Accredited Standards Committee
X3, Information Processing Systems

Doc: X3T10.1/96a142r2
Date: August 1, 1996
Project: X3T10.1/1146D
Ref Doc.: SSA-PH2 rev 1
Reply to: John Scheible

To: X3T10.1 Membership
From: John Scheible
Subject: SSA-PH2 changes proposal

Figure 6 - Test environment for drivers

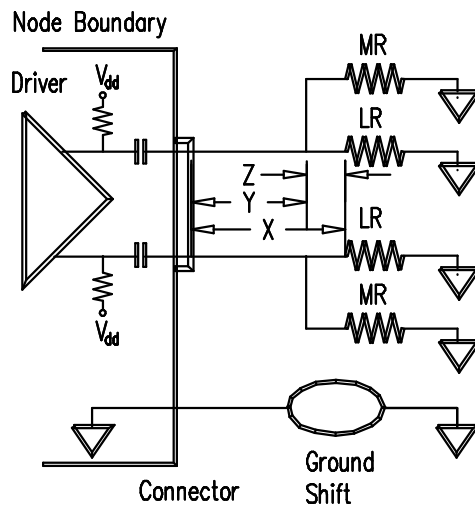
Dave Instone pointed out that rev 1 changes that were backed out should not have backed out the change from 2 pF to 1,5 pF which is restored in this proposal. Dave also pointed out the at line difference of 5 mm applied from the connector to the measurement point, and not connector to load resistor.

- a) Modify Figure 6 as shown below.
- b) Change the first paragraph of 7.1.3.1 to...

Line drivers shall be tested using the test circuit shown in Figure 6. Line Driver measurements shall be made at the port connector. The distance between the port connector and the load resistance LR (labeled X in Figure 6) shall not exceed 5 cm. The distance between the measurement point (at the LR and MR junction) and the load resistance LR (labeled Z in Figure 6) shall not exceed 5 mm. The difference between the connector to measurement point distance (labeled Y in Figure 6) of the LineOut+ and LineOut- lines of the driver shall not exceed 5 mm. The resistance of the combined load resistance LR and measurement resistance MR shall be $75 \Omega \pm 2\%$. The connecting media shall meet the requirements in 7.5 for this test. The total additional capacitive load from the scope probing scheme between Line+ and ground and between Line- and ground at the port connector shall be $1.5 \text{ pF} \pm 20\%$. This capacitance includes the sensing probes and equipment added to enable probing. Additional discrete capacitors between the scope probes and the port connector ground may be needed. The load shall conform to the characteristic impedance requirements in 7.3 at its connector.
